A.6. ALDI – MID HUDSON CENTER

SEQR review, Site Plan and Architectural Review for a proposed remodel of a portion of the existing Ocean Job Lot building retail space to operate a +/-20,567 SF ALDI grocery store, including building renovations and minor parking modifications. 3456 North Road; Grid #6062-02-990867; 9.71 acres; Zoned Fairview Center (FC) Zoning District; Type II Action; *APD Engineering & Architecture PLLC, Applicant; OSJ of Poughkeepsie LLC, Owner.*

TOWN DEPARTMENT, CONSULTANT AND FIRE DISTRICT COMMENTS

Project Name: ALDI – MID HUDSON CENTER
Parcel ID #(s): 6062-02-990867-0000
For Planning Board Meeting on: February 19, 2026

Site Plan	
Drawing Name:	Project No.
Date: 12/03/25	24-0553
Type: Retrofit	
Drawn By: ROL	C1
Scale: 1" = 30'	Drawing No.

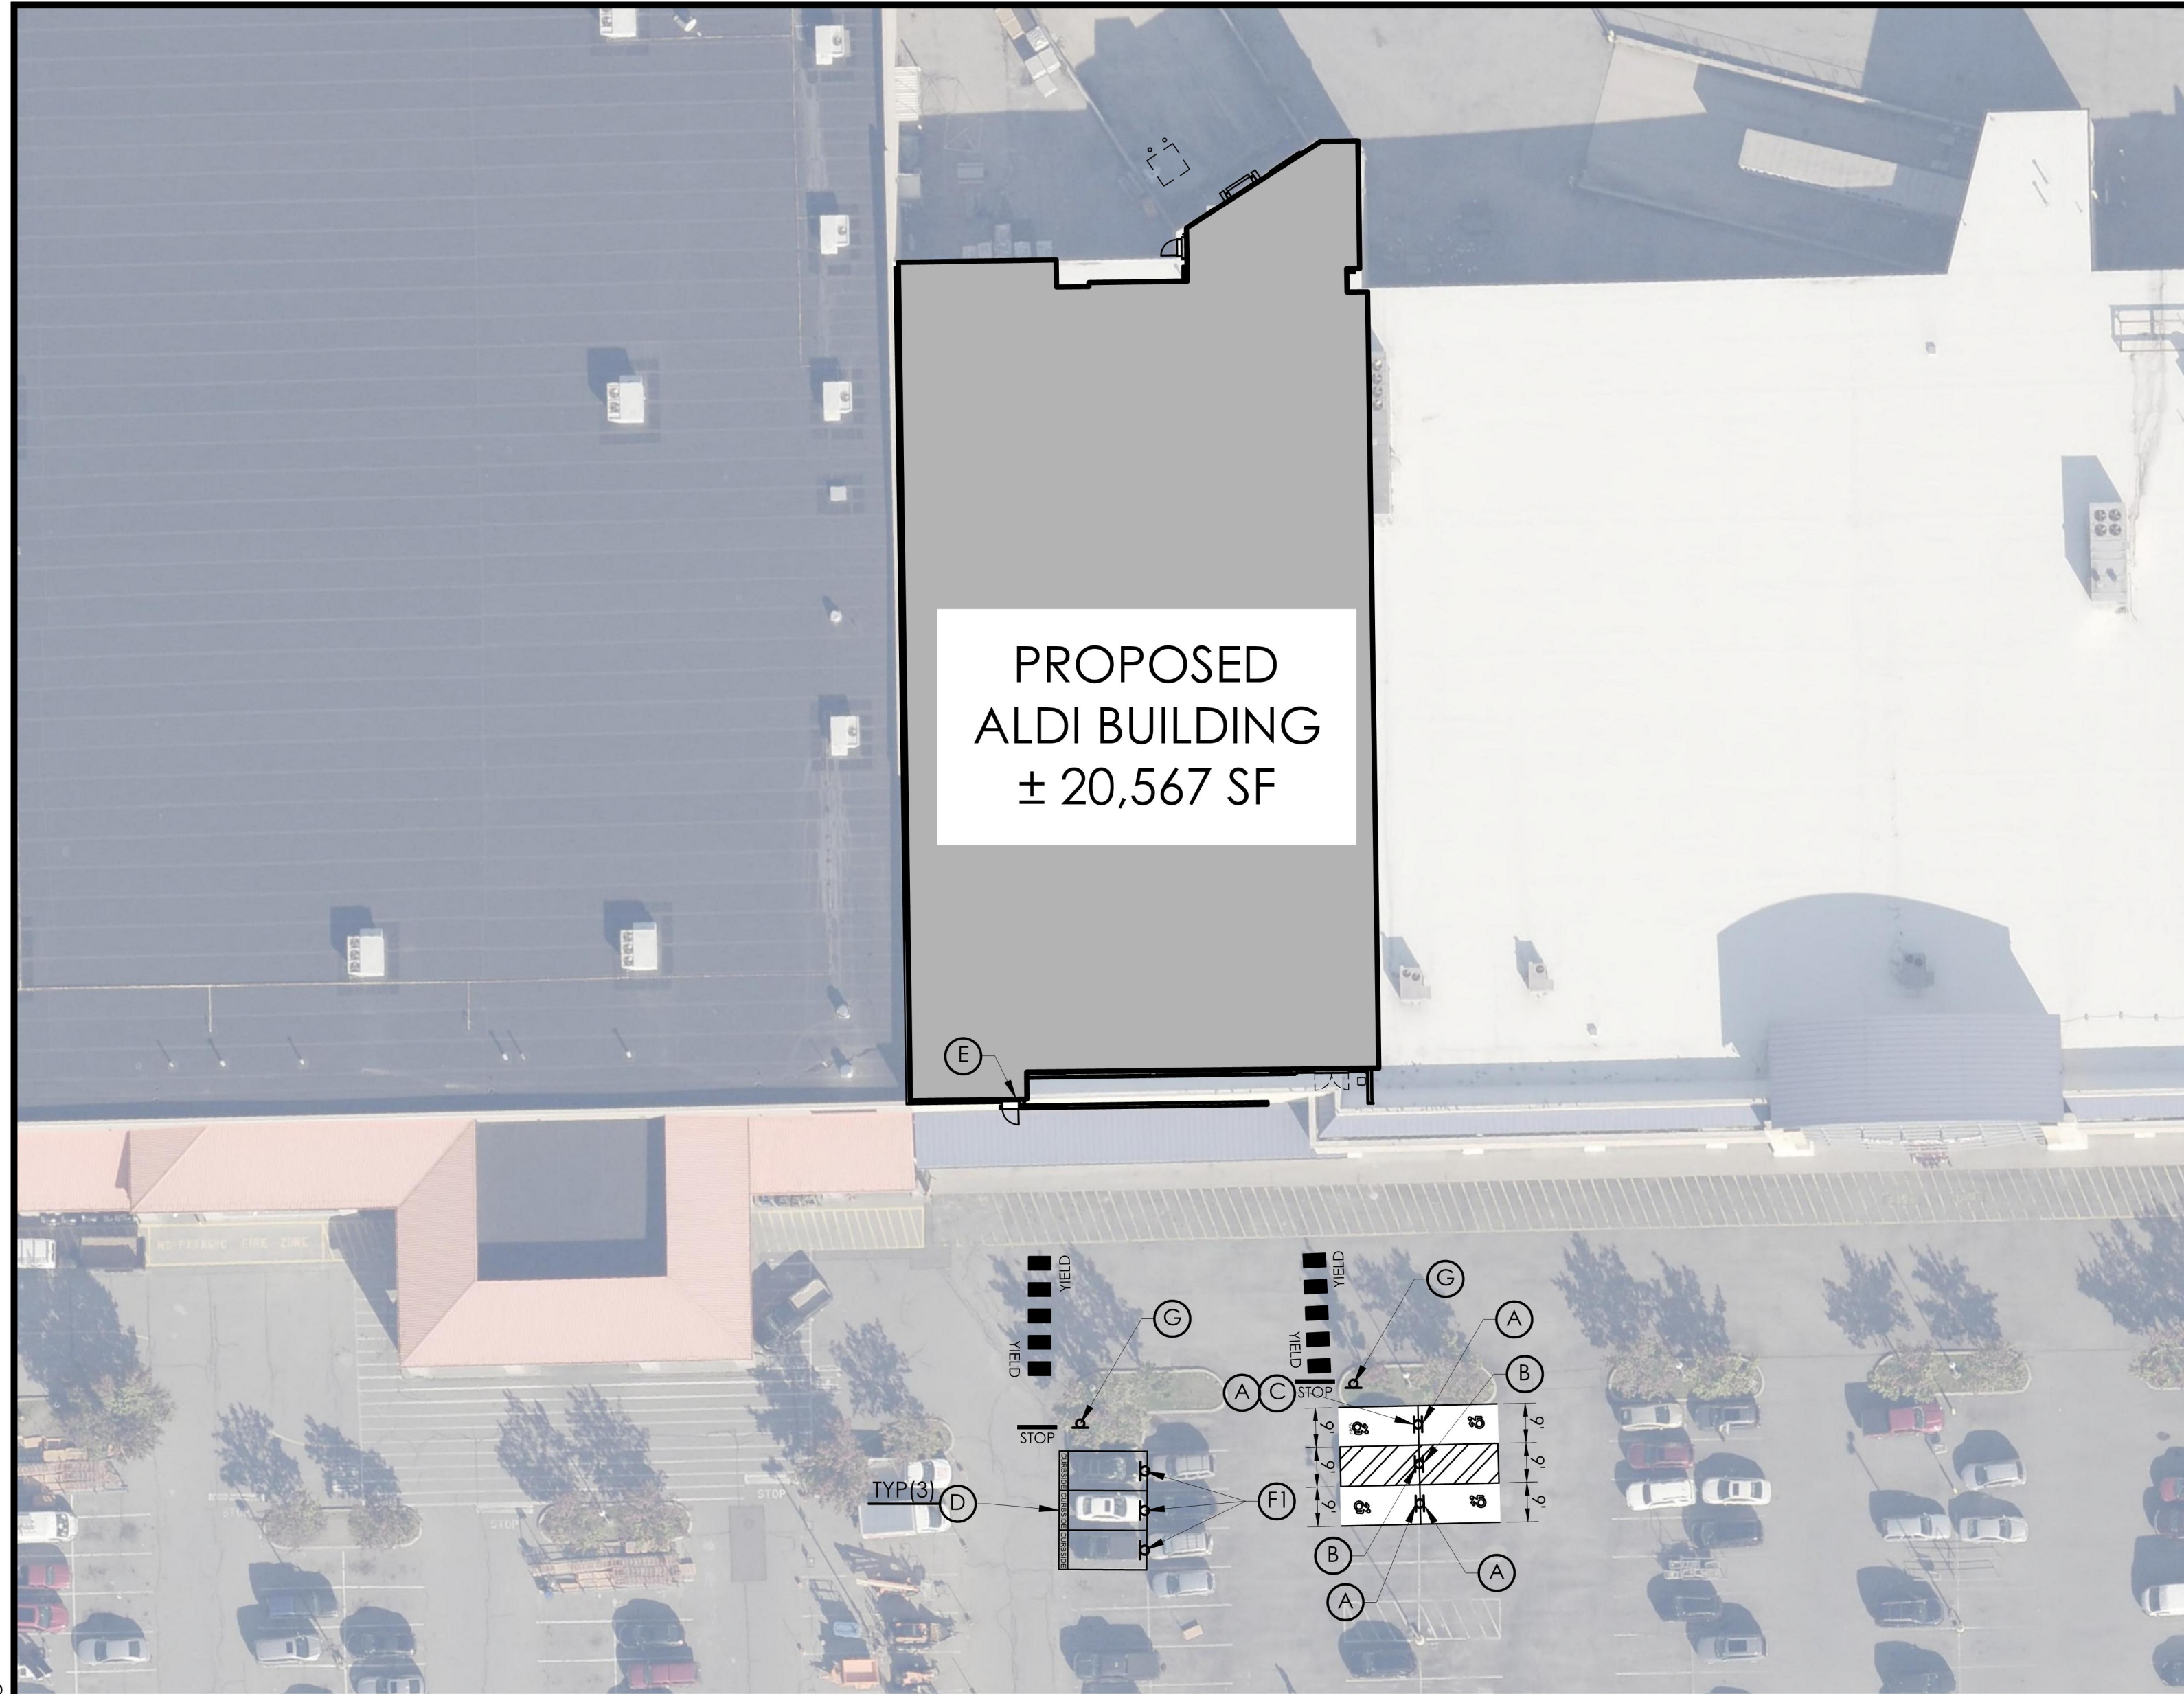
1. Applicant is to consider using or overlaying a scaled line drawing to clarify and distinguish existing and all proposed site plan conditions on Sheet C1 Site Plan, upon or in lieu of the enlarged aerial photo with labels.

2. Applicant is to revise Sheet C1 Site Plan to more clearly depict the parking layout and changes from existing to proposed conditions. In addition:
 - a. The graphic plan appears to show 6 existing parking spaces converted to 4 ADA spaces with aisles, net -2 spaces, where the Parking Schedule indicates a net +2 spaces.

- b. Show that renovated parking spaces will meet required minimum 9'x18' (minimum 8' width for ADA), and that proposed signage will not reduce the minimum 18' length.

- c. The location of "Stop" bars and signage are to be adjusted as needed in consultation with a traffic design professional. Locations near the middle of islands (especially the northern one) appear short of the relevant aisle and potentially unsafe.

- d. Provide standard crosswalk locations and design on the plan and details in consultation with a traffic design professional. Proposed locations directly in front of stop bars appears incorrect, and pavement markings are unclear and appear non-standard. "Yield" signage or pavement markings are to be similarly clarified and detailed.

- e. Signs "S", "L" and "R" in the Sign Schedule are quantified as "TBD" and not found on the plan, please locate or delete them.
 - f. Show any changes to surfaces, curbing or walkways, including those in height or slope for ADA access paths between building and parking.

- g. Distinguish existing vs. proposed building ingress/egress locations. Key or label rear ingress/egress and loading dock locations.

3. Applicant is to add a Site Plan note indicating the provision of interior shopping cart storage (reference Sheet C131) in lieu of exterior cart corrals, and daily collection of unreturned shopping carts, per applicant cover letter item #6.

4. No signage for “No Parking Anytime” was found to address prohibited parking in the main drive aisles/fire lanes, as proposed by applicant cover letter item #2, in response to pre-application meeting fire access concerns. Show signage locations, and identify the fire lane on the graphic plan.

1. The proposed crosswalks will direct pedestrians directly into the traffic lanes and stop bars, this is raising safety concerns. It is preferred that the crosswalks are removed from the site plan as there is no clear safe location to place them.

Operations Plan	
Drawing Name:	Project No.
Prototype:	VX.1N
Type:	24-0553A
Drawn By:	RETROFIT
Scale:	JLN
As Noted	A-131
	Drawing No.

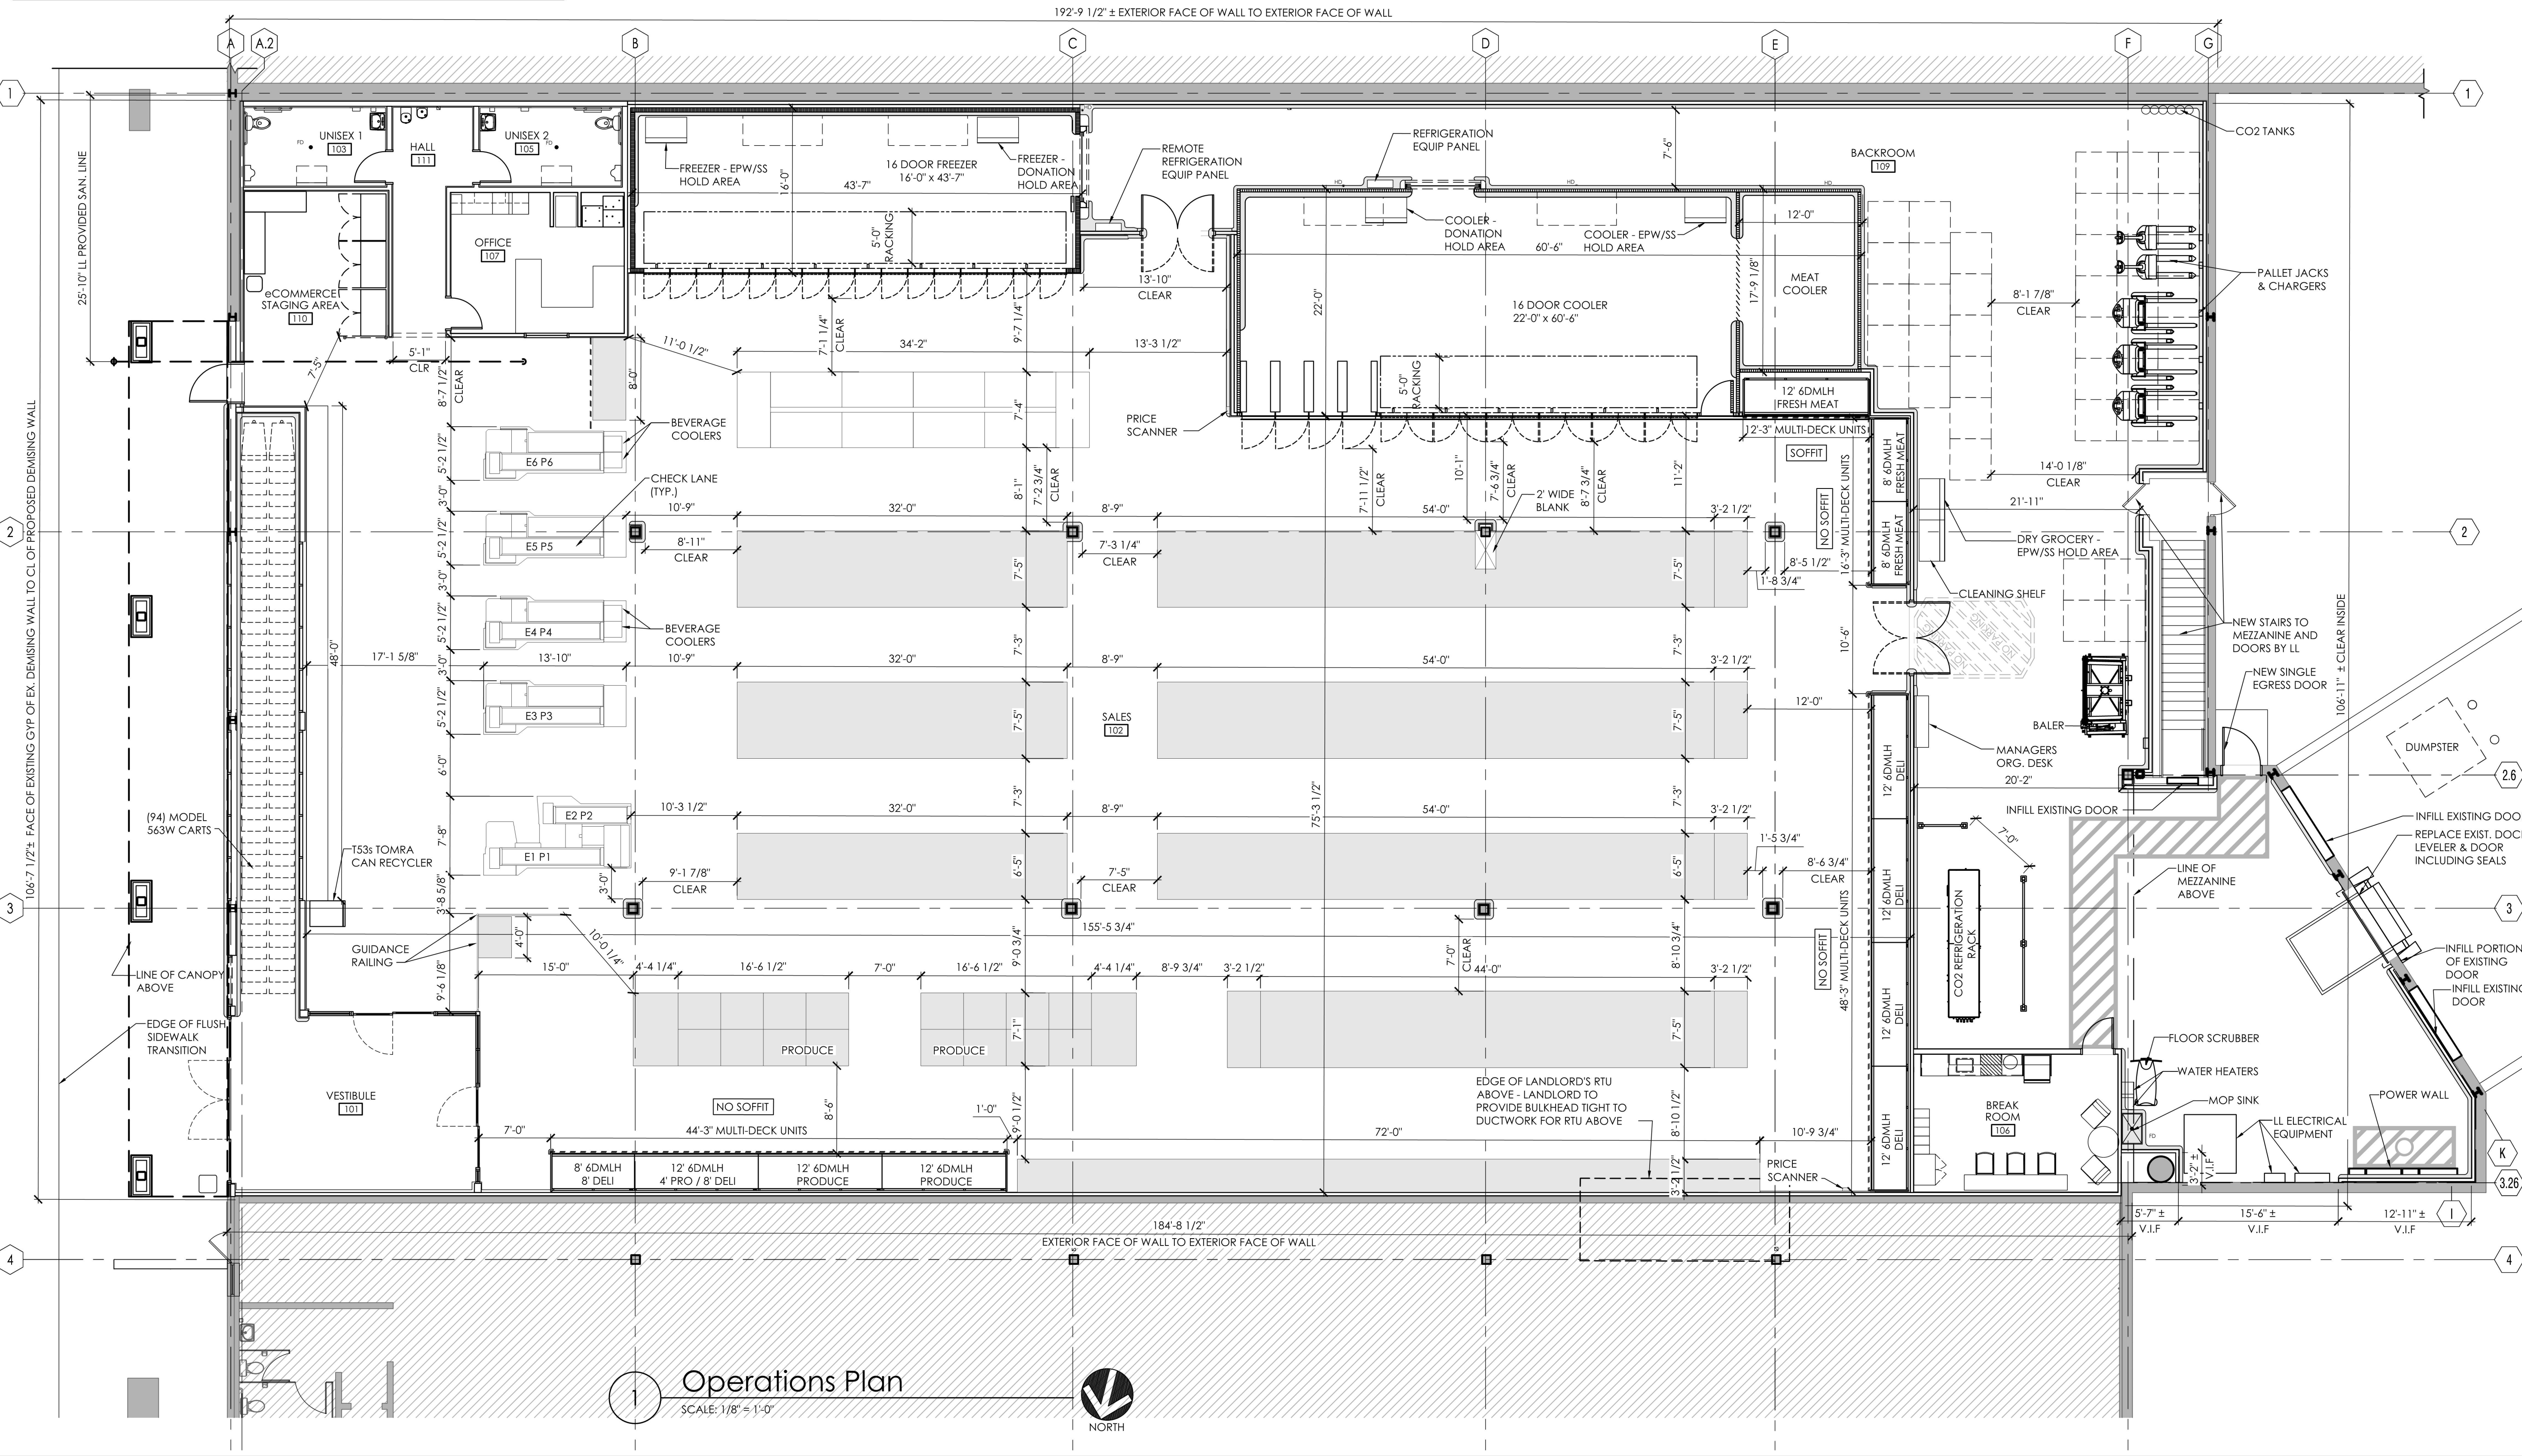
9. Site Plan Application Checklist and other information:
 - a. All plans are to be stamped and sealed by a licensed professional.
 - b. Correct North arrows on Sheet C1 Site Plan and Sheet A-131 Operations Plan, and provide the Front Elevation title with a cardinal direction (*i.e.*, West) on Sheet A-201 Exterior Elevations.

SNOW REMOVAL SITE PLAN

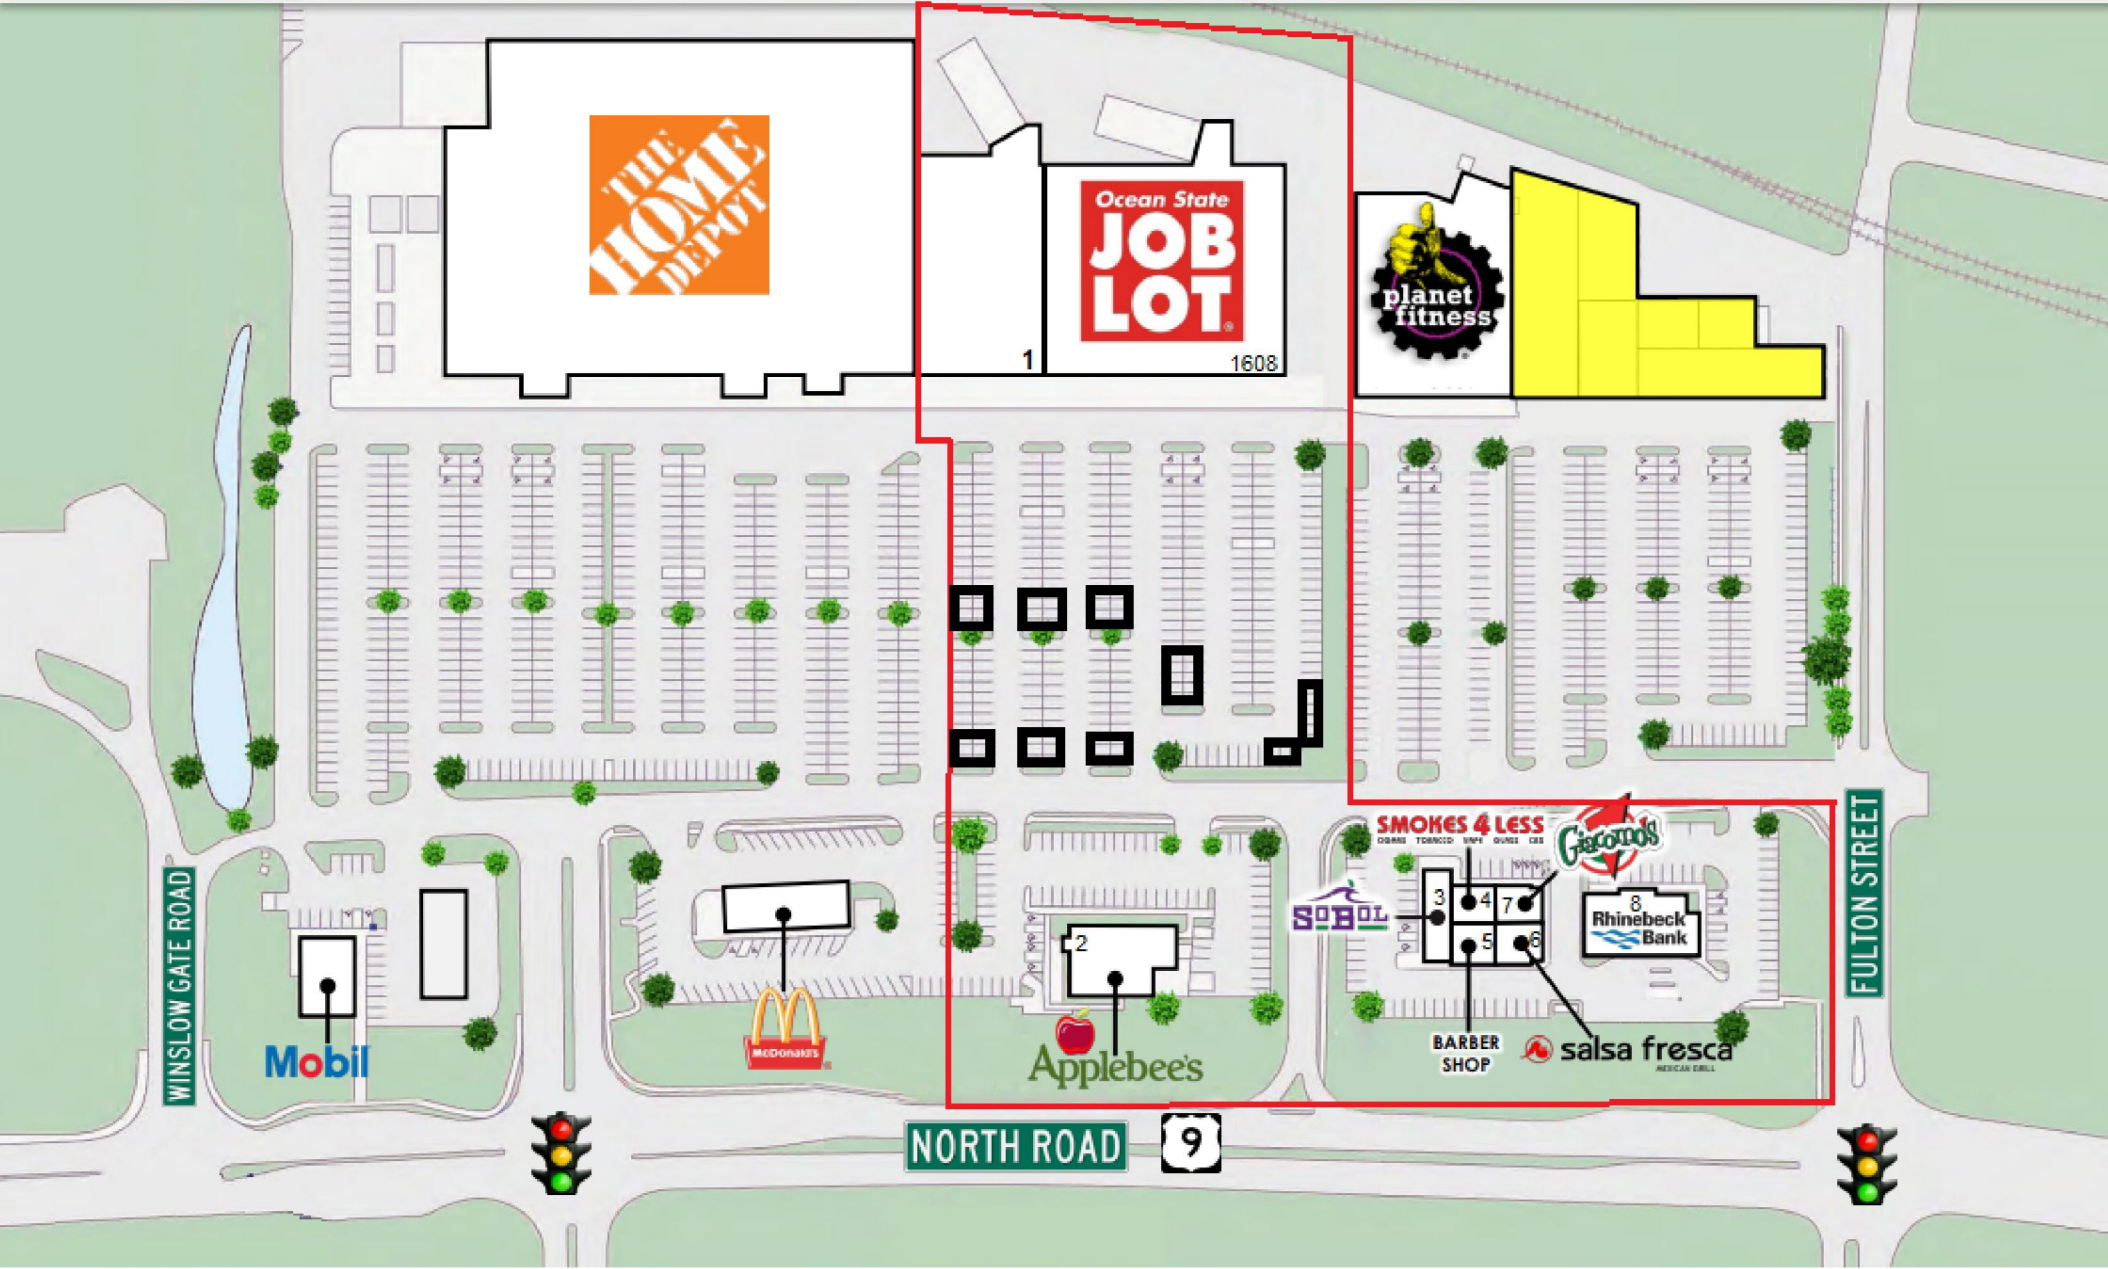
- d. Applicant is to incorporate into the plan set the Snow Removal Plan with site shared highway access, circulation and surrounding uses, submitted under separate cover (please add a north arrow).
